From: Amanda Scholes on behalf of Planning.Responses
Sent: 02 May 2017 11:21
To: Planning Scanning
Subject: FW: Response to Y_15_17_DOC condition 6
Attachments: ResponseToCondition6_Y_15_17_DOC.docx

Reference	Y/15/17/DOC
Status	Undecided
Proposal	Application for approval of details reserved by condition imposed under Y/64/16/PL relating to conditions 5-landscape scheme for HGV parking site, 6-landscape scheme along southern boundary, 7-Site Management Plan & 10-light appliances.
Location	Land to the North of John Turner P Lake Lane Barnham PO22 0AL

After reviewing the proposed planting scheme provided by SLH, '**Landscaping and Planting Plan – John Turner Phormiums FINAL v1.PDF**' we wish to submit the following comments:

The proposed tree-planting scheme

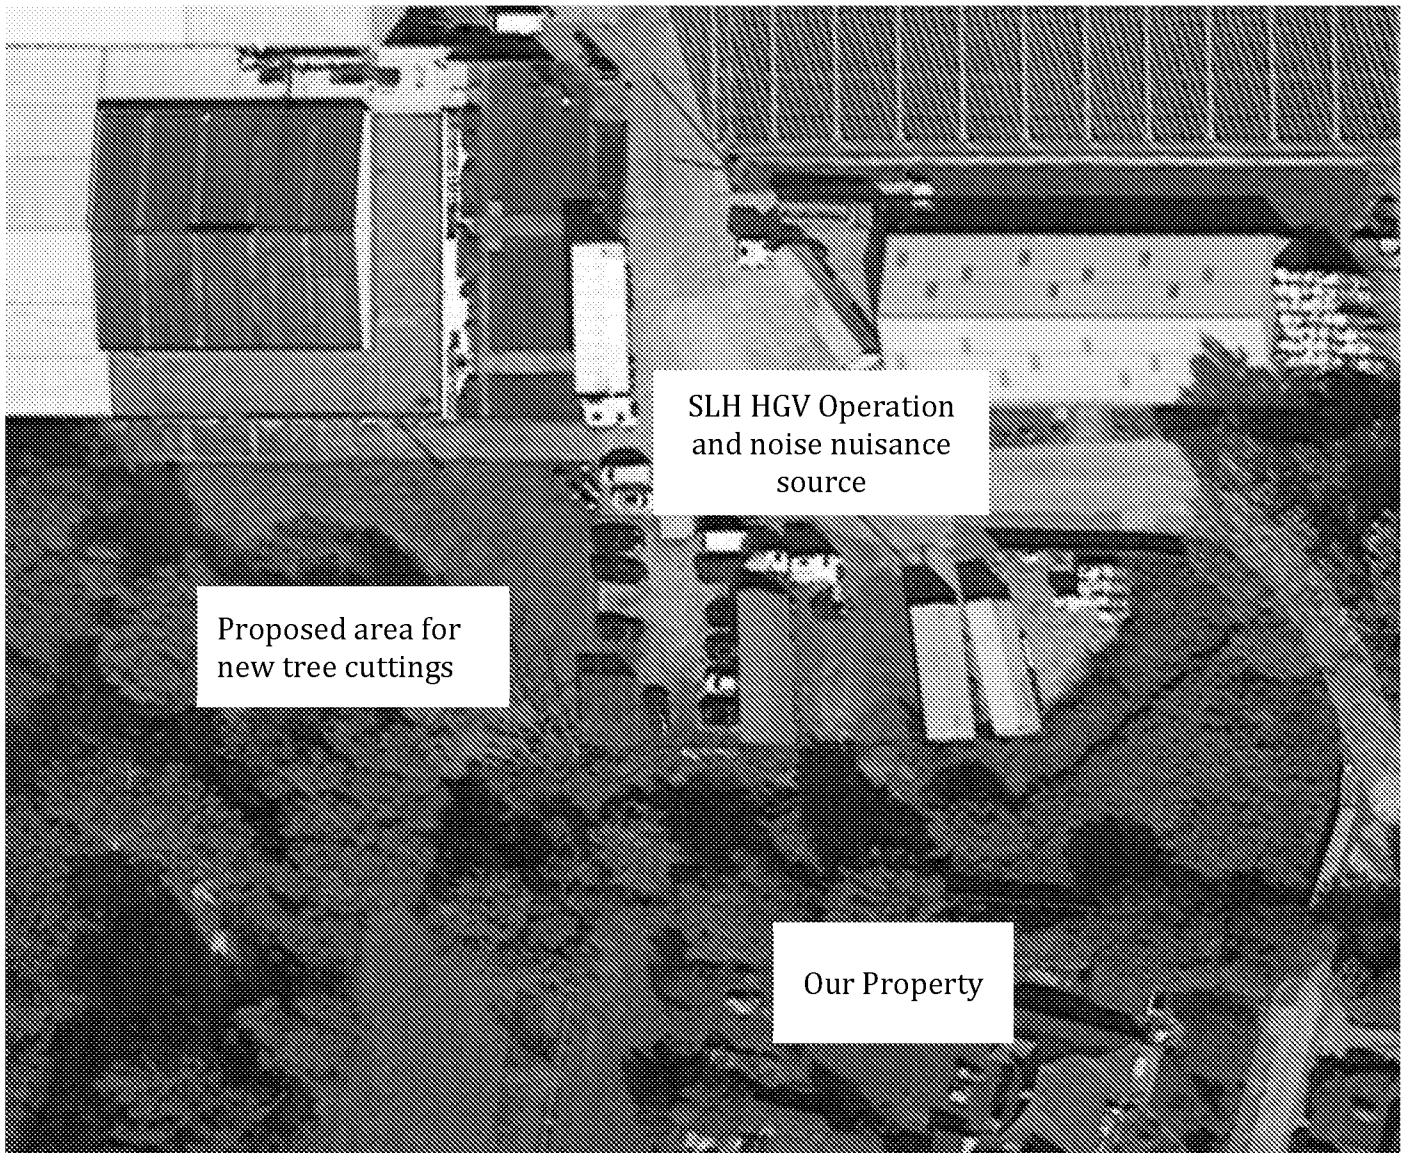
- 1) The 40m stretch in question above starts to the west after our property finishes; how will this provide further noise mitigation for the amenity and enjoyment of our house and garden, and to what levels?
- 2) Although a 40m stretch is quoted, the specification actually states a 'minimum' of 10 new trees will be planted, and goes on to reference them as 'cuttings'; how many trees will be planted, and how mature will they be at the time of planting?
